**INSTALLATION AND SERVICE DIVISION**  
**RCA MANUFACTURING CO., INC.**  
 CAMDEN, N. J.

<b>CLASSIFICATION</b> Technical - Photophone - Amplifiers	<b>DATE</b> Oct. 26, 1937
<b>SUBJECT:</b> MI-4237, MI-4230-X VOLTAGE AMPLIFIERS	<b>NUMBER</b> SL-2C3-3.10
<b>TO:</b> A-5, B-1, B-2, B-3, B-4, C-7, D-7, E-7, F-7, G-1, G-2, G-3, G-4, H-7

**Figure 2 - Wiring Diagram - MI-4237 and MI-4230-X**

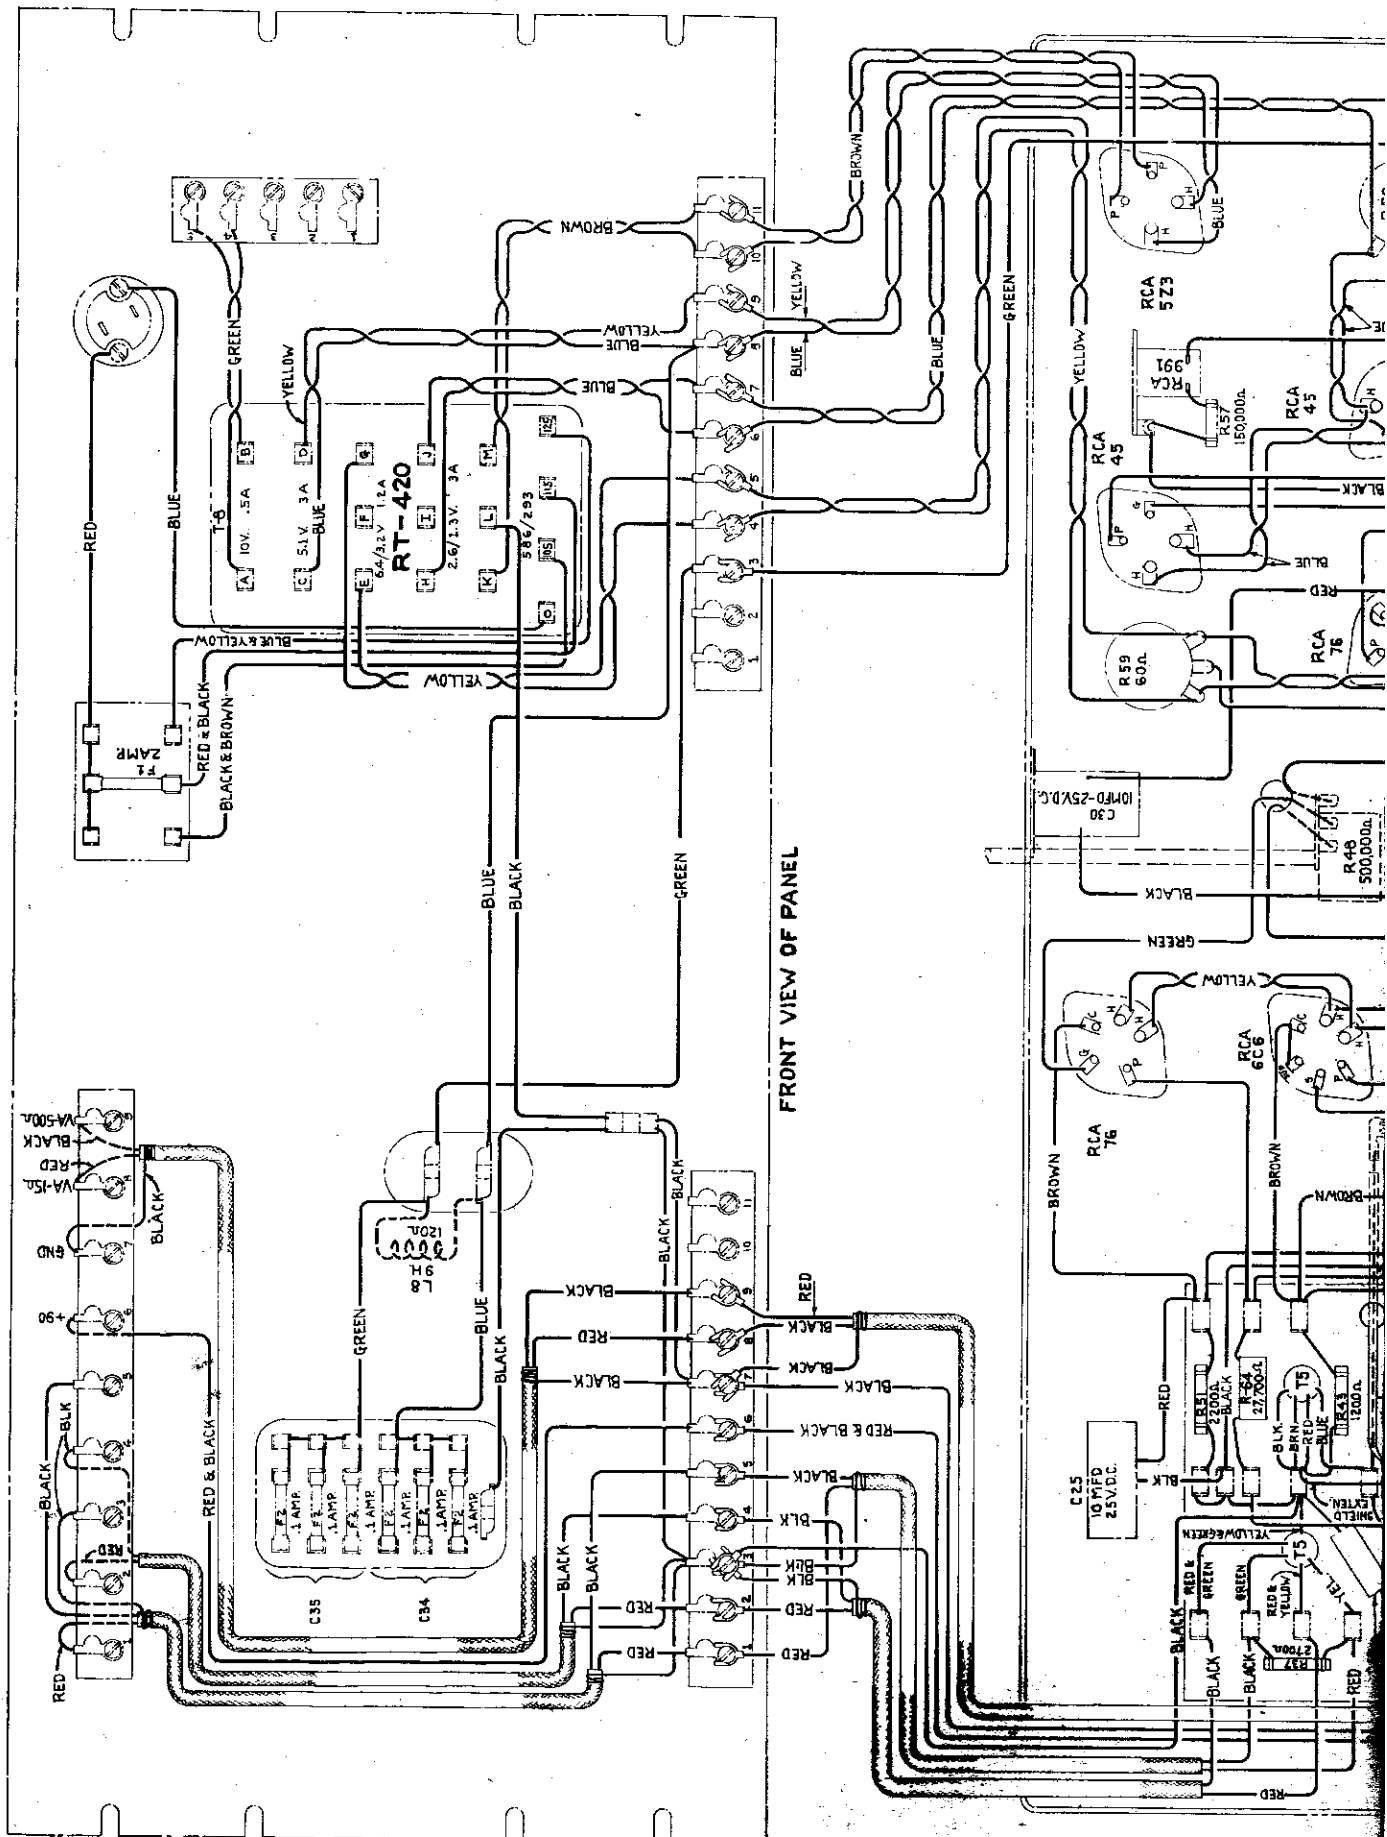
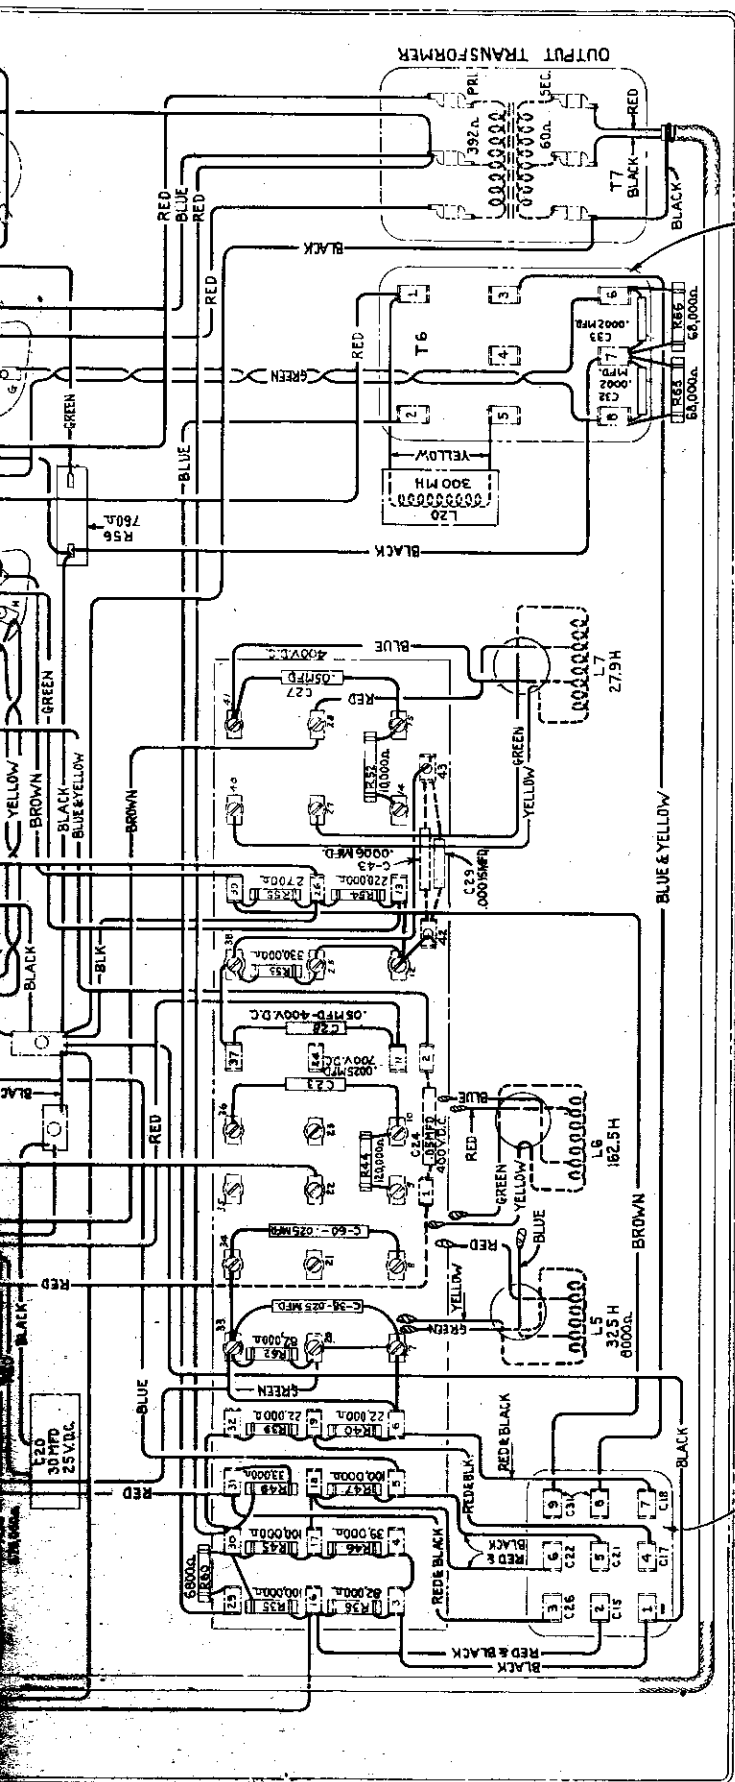
The MI-4237 voltage amplifier is similar electrically to the earlier type MI-4230 voltage amplifier with the following exceptions:

1. The low-frequency booster reactor, L-5, has been disconnected.
2. R-41 (100,000 ohms) is now R-62 (82,000 ohms).  
 R-62 and C-38 are shunted by a bus wire. (Terminals 6 & 7)
3. C-38 was a single .05 mfd. capacitor and now consists of two .025 mfd. capacitors, Stock No. 4870.
4. R-63 (27,000 ohms) was R-42 (120,000 ohms).

5. R-64 (27,700 ohms) was R-50 (33,000 ohms).
6. C-29 (.00075 mfd.) consists of two capacitors, one (.0006 mfd.) Stock No. 42537 and one (.00015 mfd.) Stock No. 43024.
7. The 300 MH reactor, L-20, Stock No. 6442, has been added in the plate circuit of the second RCA-76 stage.
8. The first stage RCA-6C6 was an RCA-24 tube.
9. Second and third stages RCA-76 were RCA-56 tubes.
10. R-65 and R-66 (68,000 ohms each) have been added from each RCA-45 grid to ground.
11. The power transformer (T-8) is now RT-420 to supply 6-volt filaments.
12. The volume control R-48 is now in 2 db steps instead of 2.5 db steps.

Figure 3 - Film Response Characteristics with Recommended Circuit Modifications

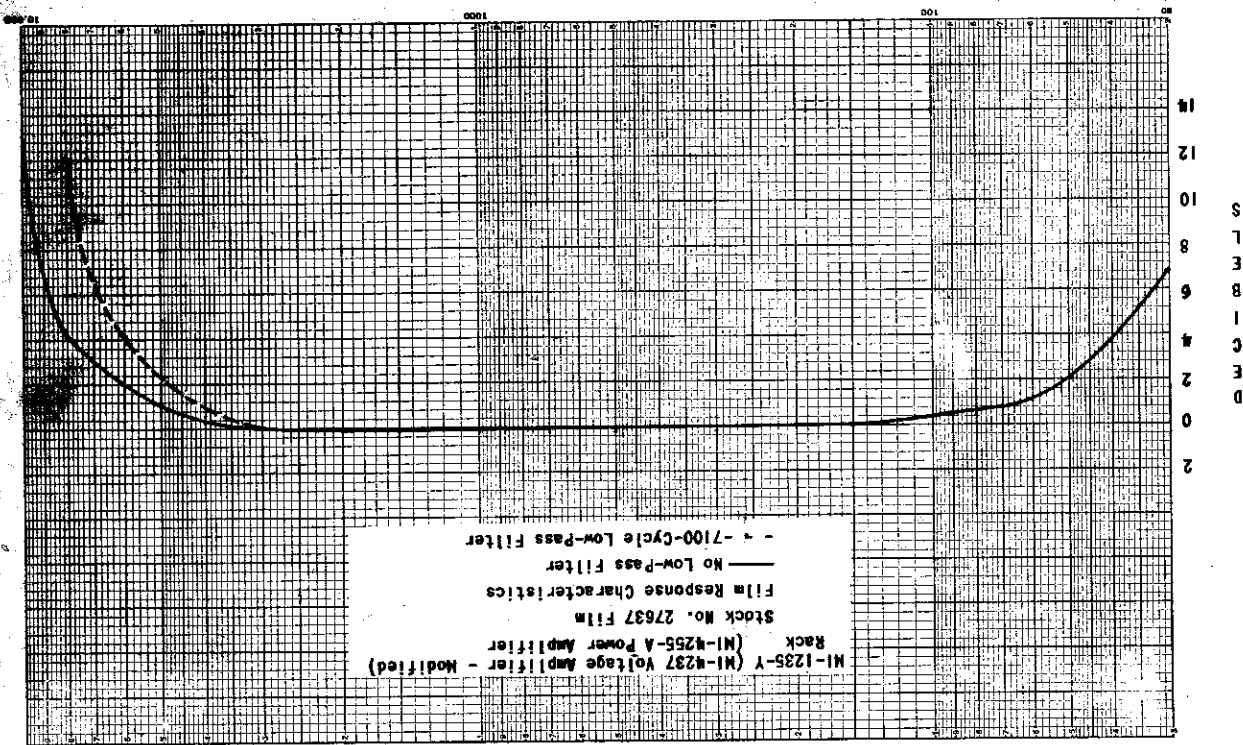
### Recommended Circuit Modification

4. Change R-63 to 82,000 ohms.
  2. Change R-62 to 50,000-ohm, 1/2-watt resistor.
  3. Change C-38 to .003 mfd. capacitor, Stock No. 42952.
  4. Add a 4 H reactor, Stock No. 6442, in parallel with the new R-62/C-38 combination.
  5. Disconnect the .0006 mfd. capacitor, C-29, leaving C-43 in the circuit.
  6. Remove R-65 and R-66.
  7. Shunt out L-20 with a bus across terminals 4 and 5 on T-6.
- A few slight modifications from the MI-4237 circuit are recommended if it is desired to obtain over-all film response characteristics shown in figure 3.
